Middlesex County College
Campus Sprinkler Upgrade – JLC & LIB
Bid #18-21

August 17, 2017

Addendum No. 1

Inspection Repairs & Notes

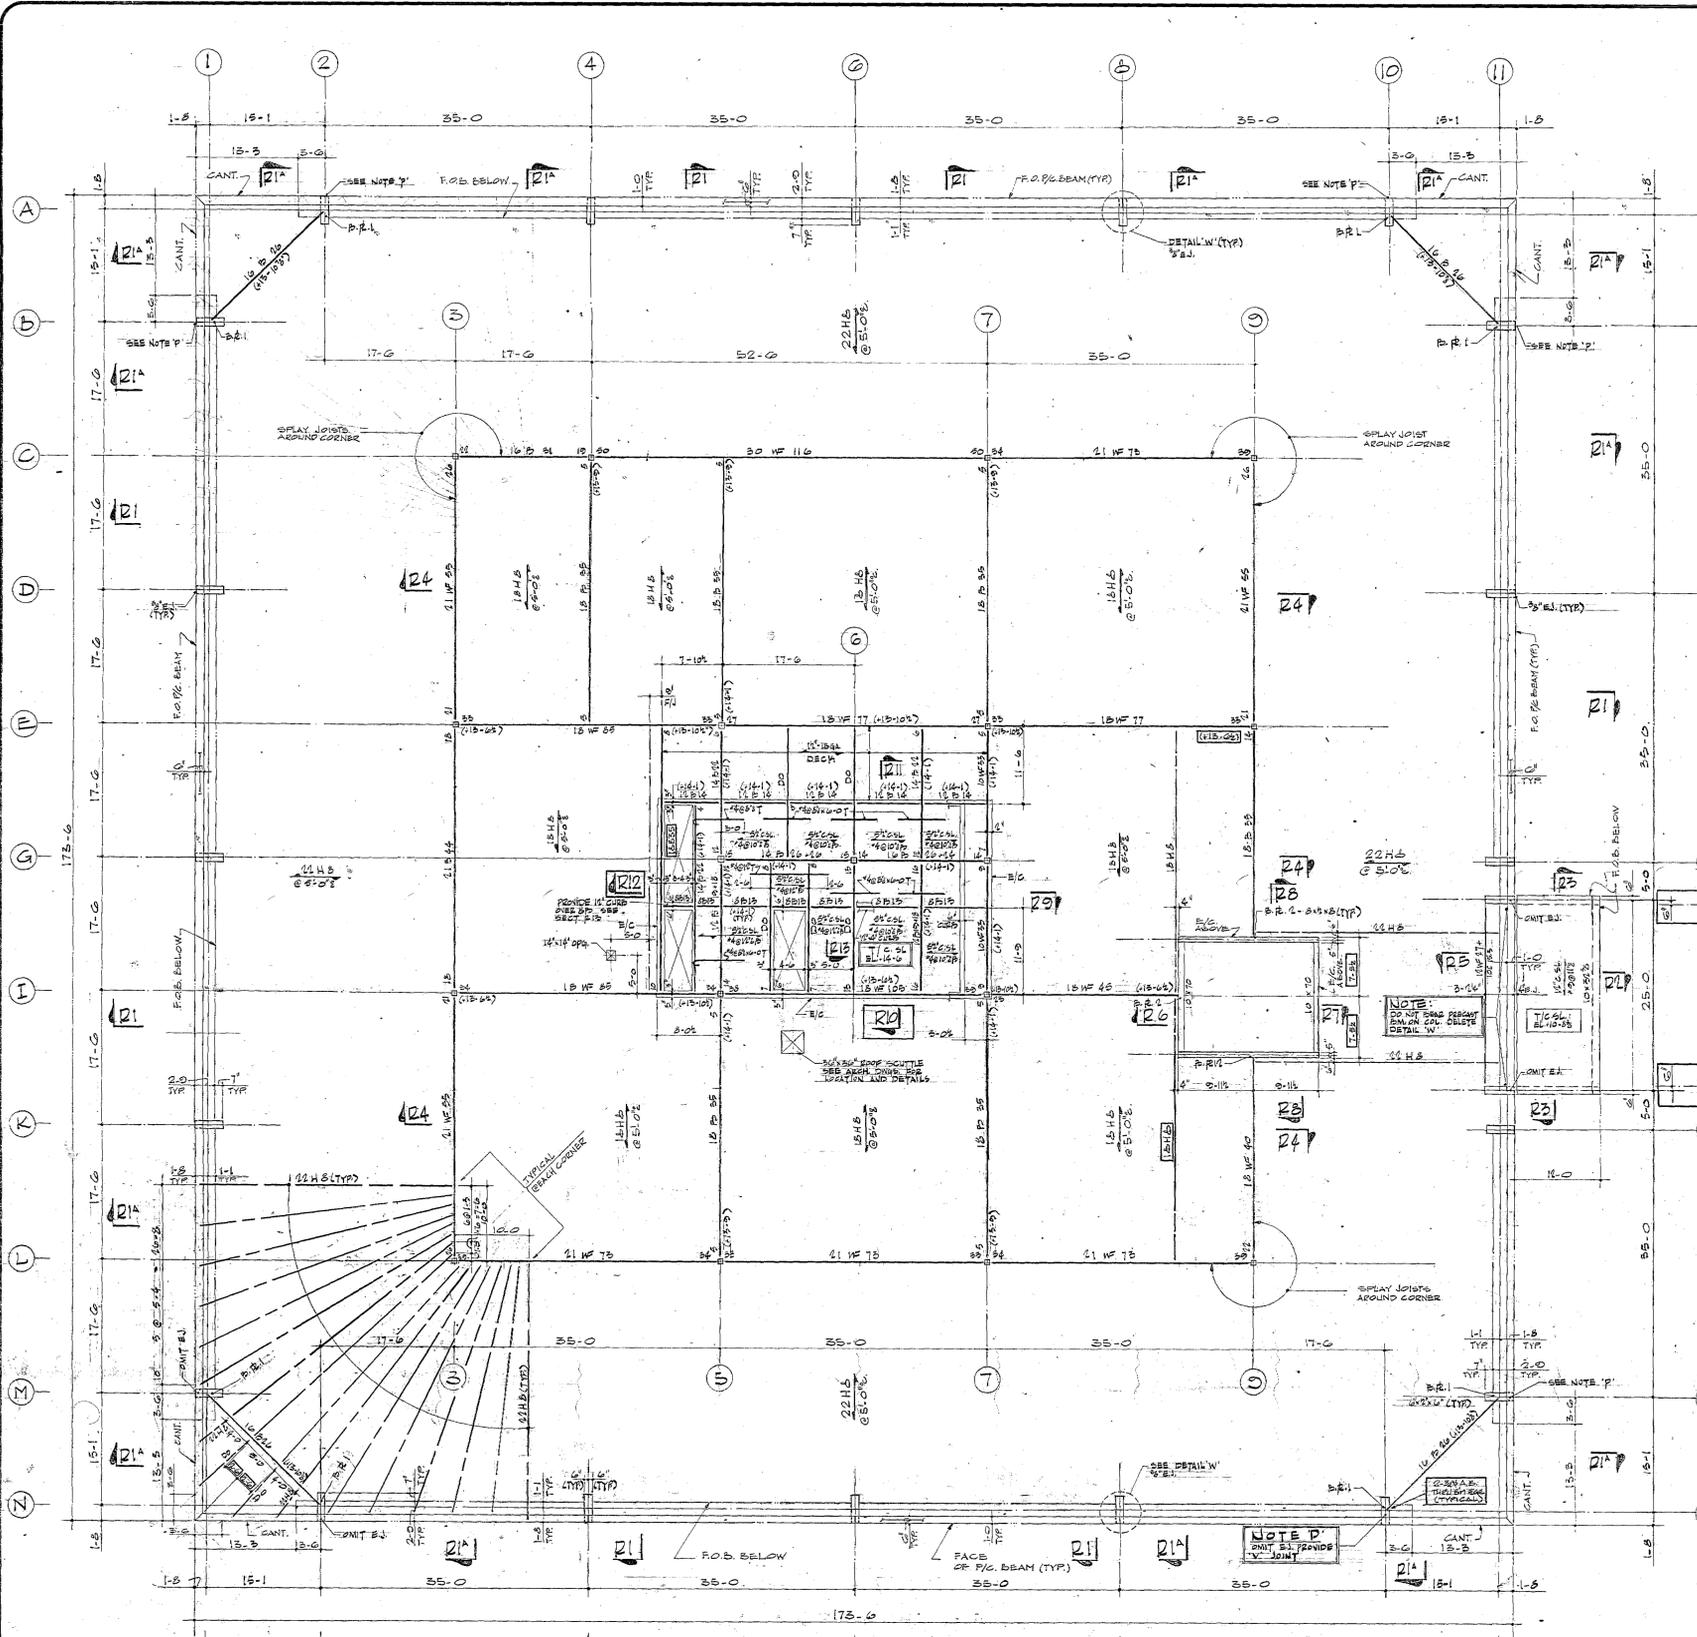
Q1: Is the existing Water Flow Test data available (this would be used for estimating purposes only)?

The flow test results from the design phase are no longer current (dated: 11/14/2014). The existing flow test has been posted for reference only. A current flow test will be required for the new design.
